Access Compliance Report

Public Rights-of-Way

(Curb Ramps)

Intersection ID: 15827	Main Street: CLANTON_RD	Cross Street: PELTON_ST	Location: NE
ADA ID: 1A09096C127D	Ramp Type: Directional1	Initial Pass/Fail: Fail	Overall Compliance: No
		Severity Score: 12.5

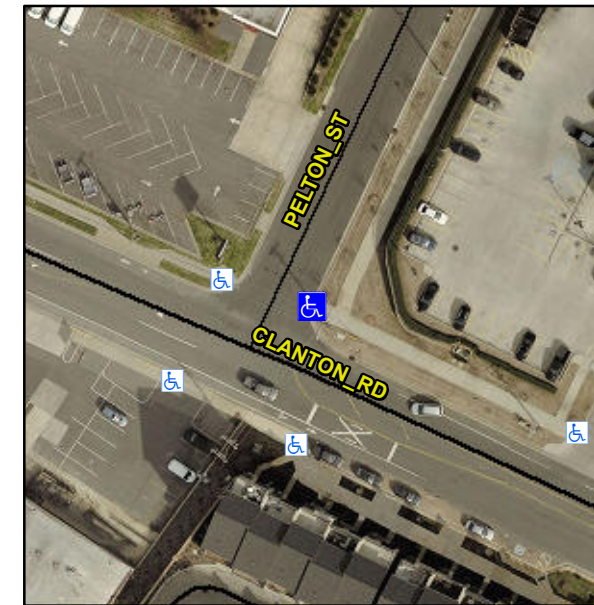
R304.2.2

Remove & Replace Entire Ramp.
